Date: May 19, 2008

To: Planning Commission

From: Ken Strelo, Senior Planner

Project: Neroly Commercial Center Phase II (PLN-2008-0416)

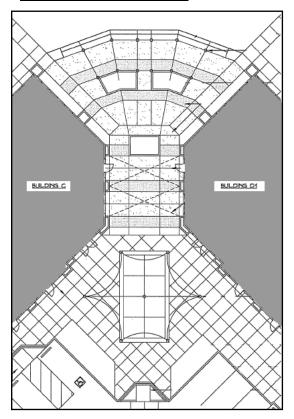
corner plaza area (Sheet A1.2), special paving areas, and the anticipated use (Retail, office, or drive-thru) for each building (See building pads in Attachment 2). The image to the left shows an enlarged detail of the plaza area on the corner of Neroly Road and Empire Avenue.

<u>Plaza Areas</u> – The plaza area located between buildings C1 and D1 consists of a bench wall and enhanced paving near the intersection and a fabric shade structure with lighting closer to the parking area (see diagram on Page 3). Other smaller pedestrian plazas are located between buildings D1 and D2 (retail buildings) and G and H (office buildings). These pedestrian plaza areas encompass the intent and spirit of the design guidelines by providing an opportunity for customers and employees to enjoy the outdoor air in a shaded environment so that they may be used during all four seasons.
